DATE: May 19, 2025
TO: Potential Respondents
FROM: Carrie Stoeckert—Construction Contract Expeditor III
SUBJECT: Questions #1
RFCSP752-25-1005CS
Kerr Dining Hall Renovation

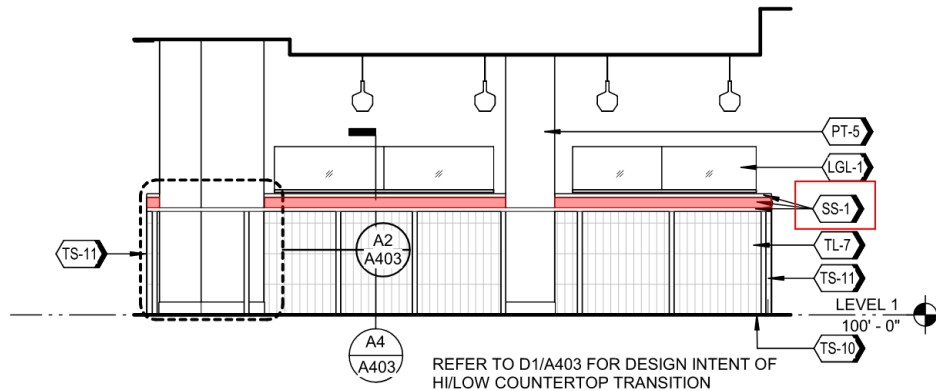
14. Demolition General Note R on sheet AD101 indicates to sawcut and remove portions of concrete floor slab for installation of underfloor plumbing lines, and for installation of recessed slab at walk-in cooler and freezer, and replace/patch back slab following installation of those items. Please provide structural floor plan and details showing the extent of this work. Please provide information regarding the existing foundation slab.

ANSWER: Note is incorrect and will be removed in upcoming Addendum. Modification of structure in any way is not required. Any plumbing line installation will involve poke-through penetrations and not sawcutting/removal of portions of the concrete floor. Walk-in cold storage assembly does not require slab recess. Kitchen floor finish should extend flush into walk-in cold storage with a smooth, level threshold with the finish floor.

3D - BAR TO COUNTER HEIGHT TRANSITION, TYP.

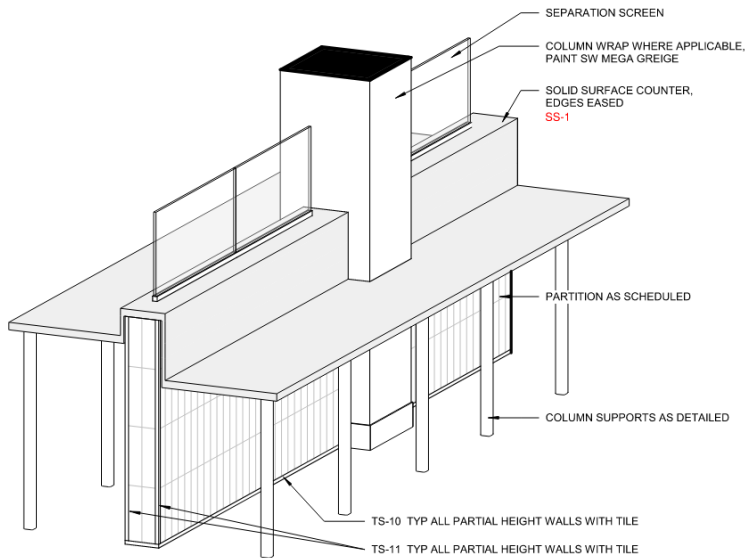
15. Please verify that the dining bar to counter in detail A1/A403 is to be SS-1 solid surface.

ANSWER: Confirmed. Countertop in detail A11/A403 is SS-1 solid surface.

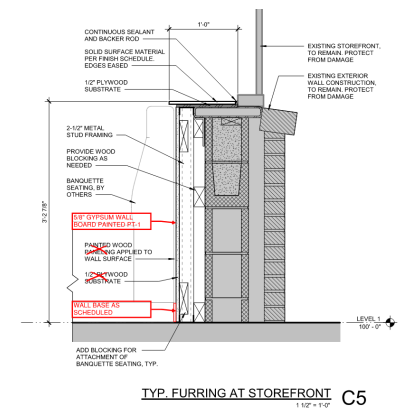
64. Please confirm if cold formed metal framing infill is required between tube steel in details E2 & A4/A403, and C3 & C5/A407.

ANSWER: Infill as required with metal stud framing between the tube steel for installation of tile backer board substrate. Note will be clarified in upcoming Addendum.

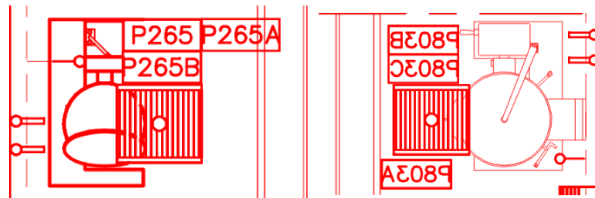
70. Items P265 and p803B on the food service plumbing schedule are incomplete. Please clarify what these items are specify their locations.

ANSWER: Refer to snapshot below for revised plumbing schedule and snapshots showing locations of each item.

P803A	3/4"	NATURAL GAS	KETTLE 60 GALLON	WALL	18"	BTC: 150 MBTU/HR
P803B	3/4"	HOT & COLD WATER	KETTLE	WALL	24"	BTC:
P803C	4"	HUB DRAIN	TRENCH LINER	FLOOR	-9"	BTC, CRITICAL LOCATION

P265	4"	HUB DRAIN	KETTLE TRENCH LINER	FLOOR	-9"	BTC; CRITICAL LOCATION
P265A	3/4"	H & C WATER	KETTLE	WALL	13"	BTC
P265B	3/4"	NATURAL GAS	KETTLE	WALL	18"	BTC: 100MBTU/HR

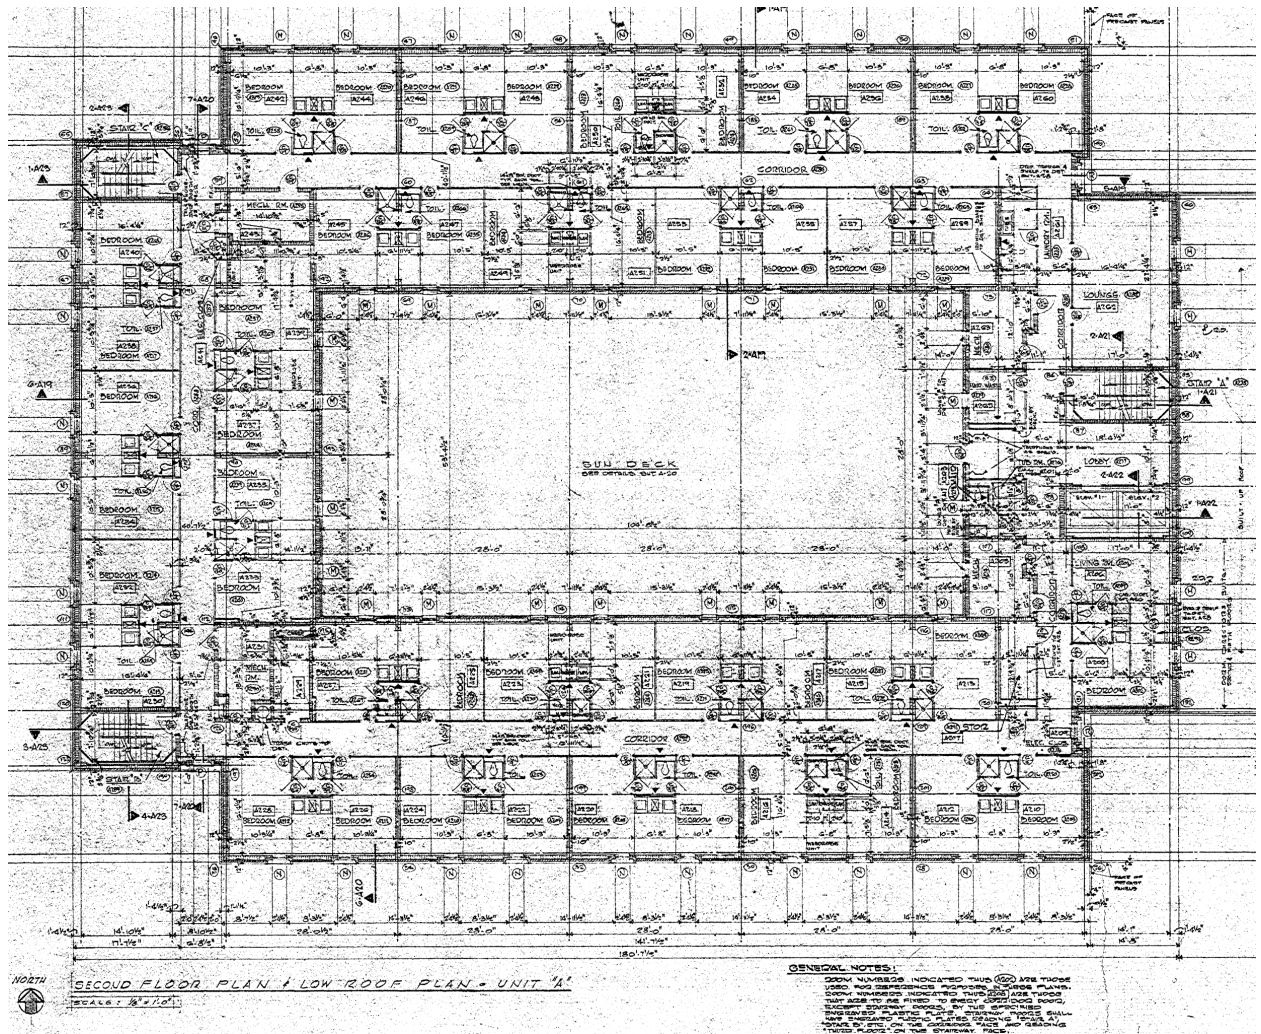
82. On M211B there is a FCU-K1-2 that is not scheduled on M601. Please rectify.

ANSWER: **Only the FCU serving the storage room is in scope. iM211B is to be resubmitted showing the updated plans.**
